RE: City of Duluth Bid #12-4403  
New Passenger Terminal Bid Package 2C  
Wayfinding Rebid & Hazardous Materials Abatement

Addendum No. 1

## **2.2 Drawing Change**

### **Drawing G100**

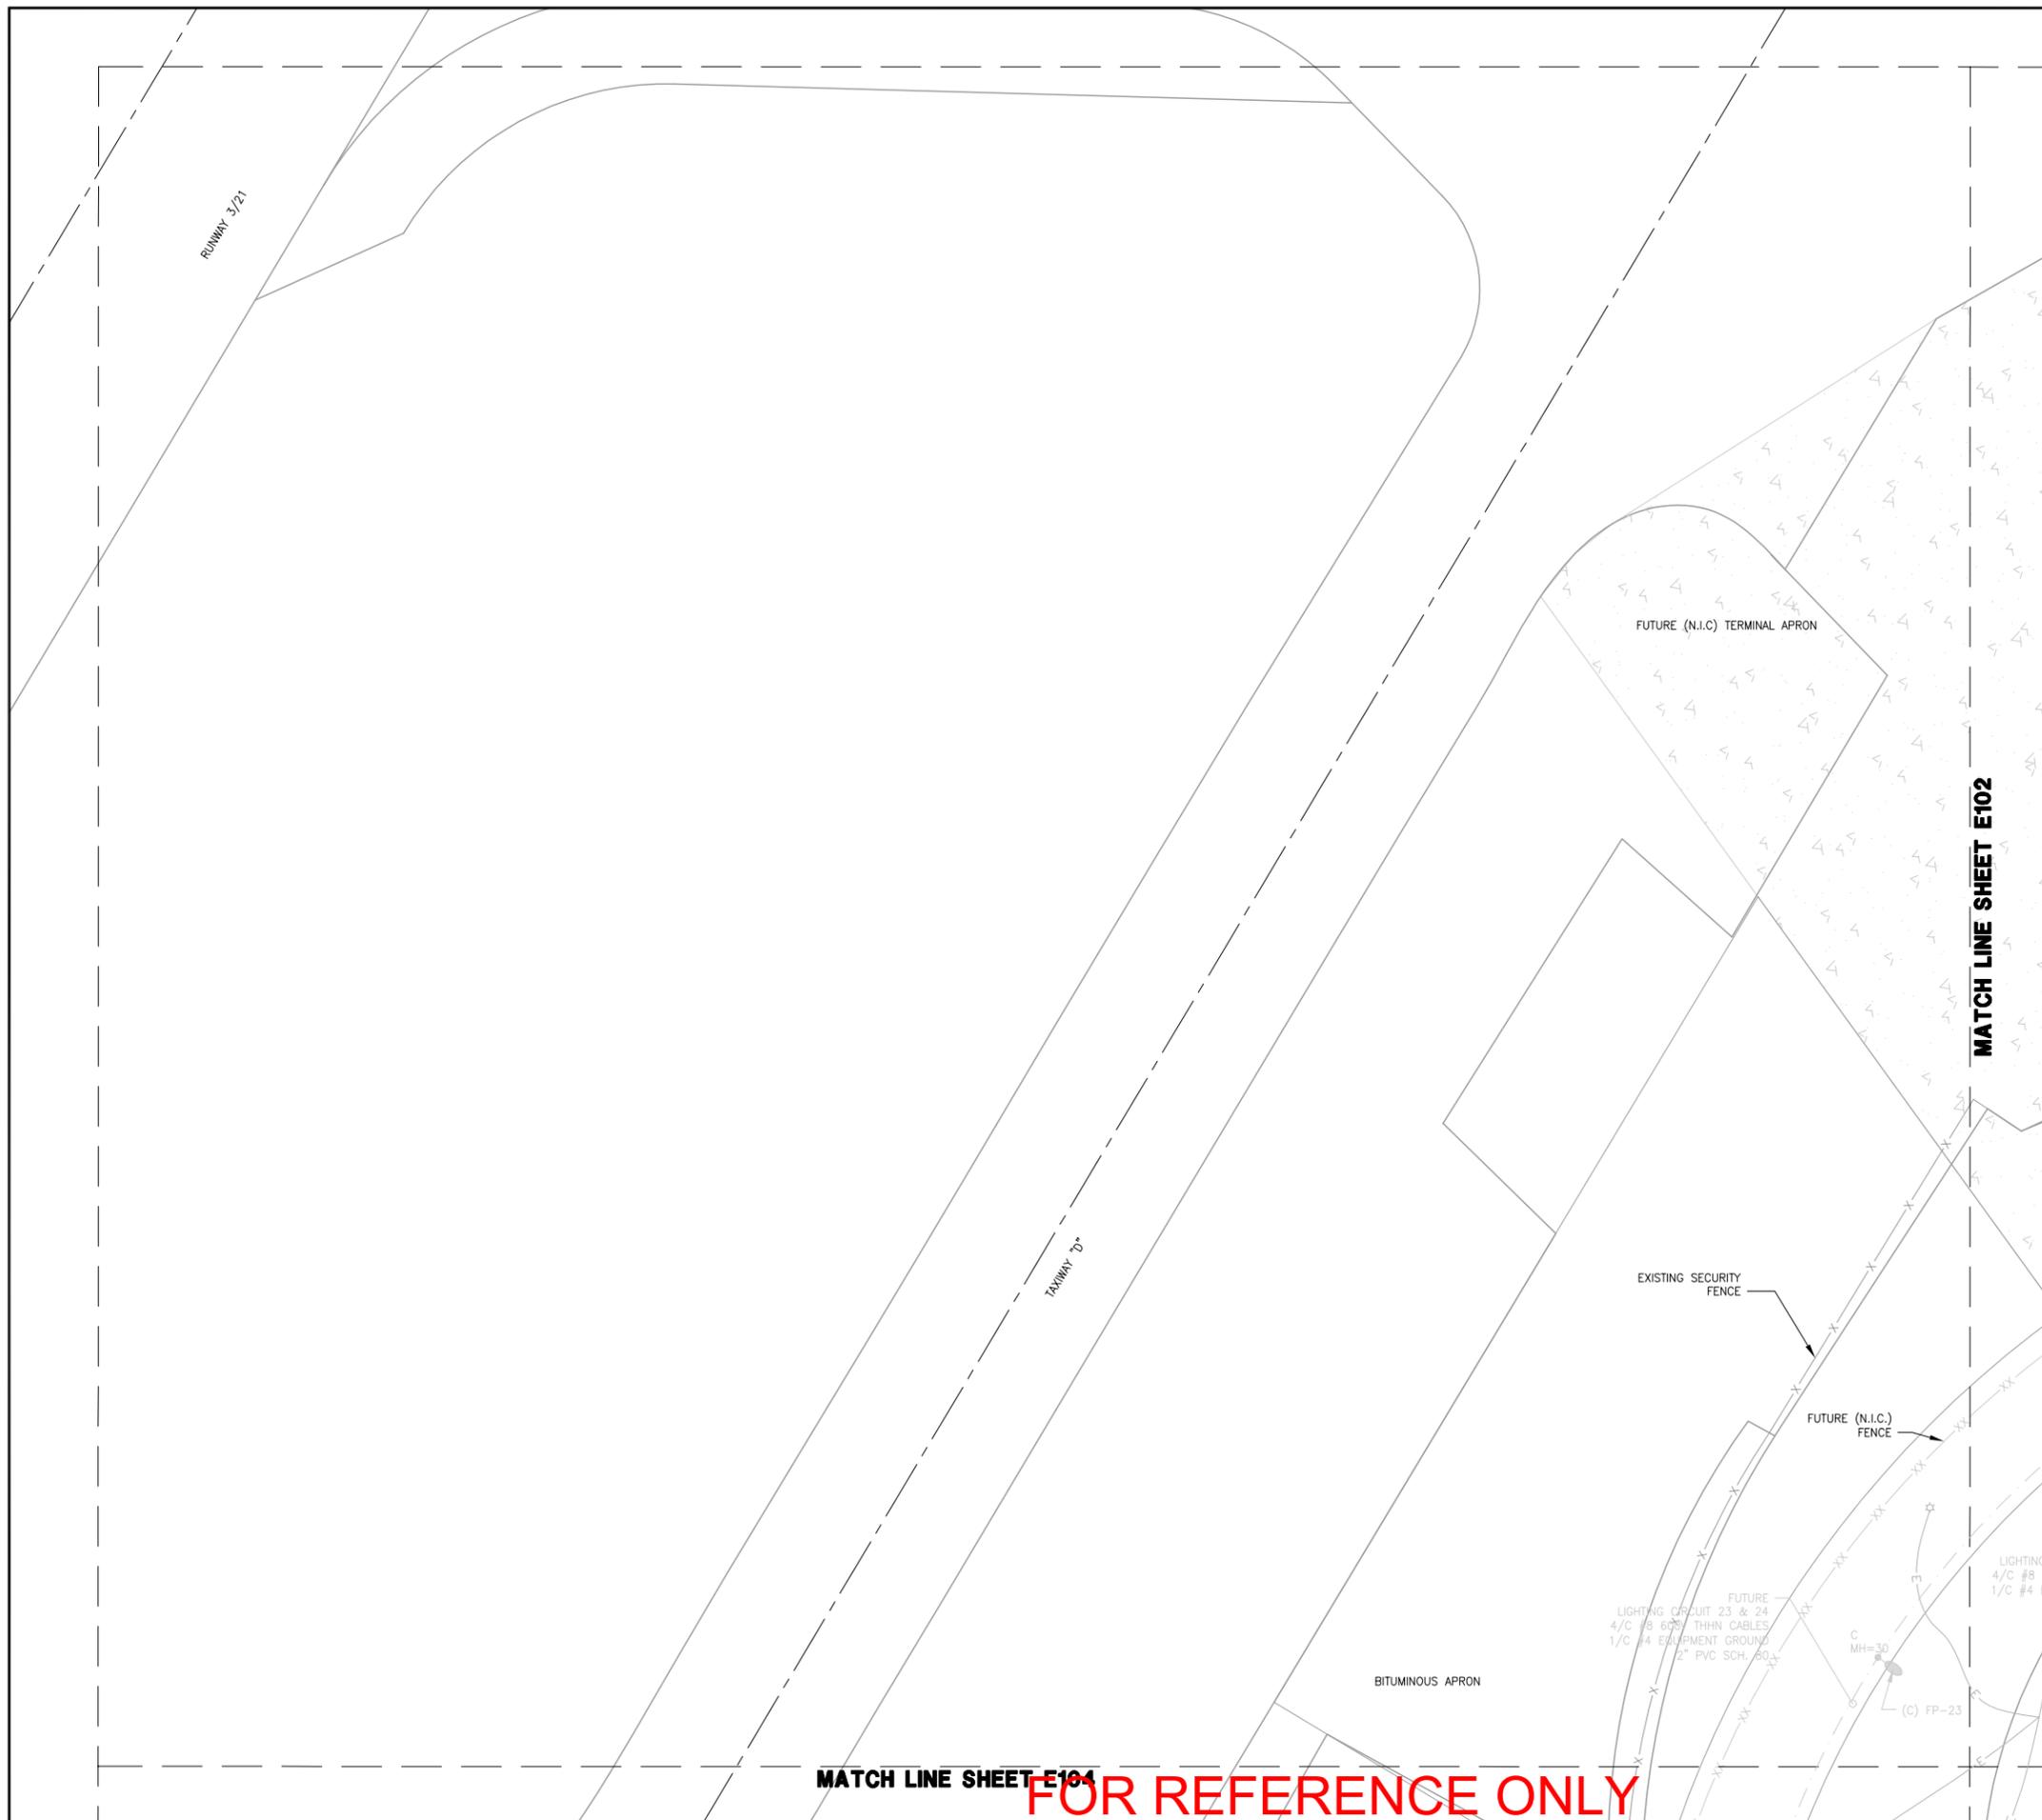
1. Add Electrical Notes as follows:
  - a. Provide 277V power for sign illumination as follows:
    - i. Signs E/01, E/04, E/05, & E/08 may be connected to perimeter roadway lighting circuit FP-9 or FP-10.
    - ii. Sign E/13 may be connected to roadway lighting circuit FP-5
  - b. All wiring shall be in conduit.
  - c. Existing circuit splice shall be done in handholes.
2. Add note as follows:
  - a. The contractor shall retain a certified utility locating service to locate all private (DAA owned) utilities within the project limits. It shall be the contractors responsibility to locate all private utilities as necessary to complete the work.
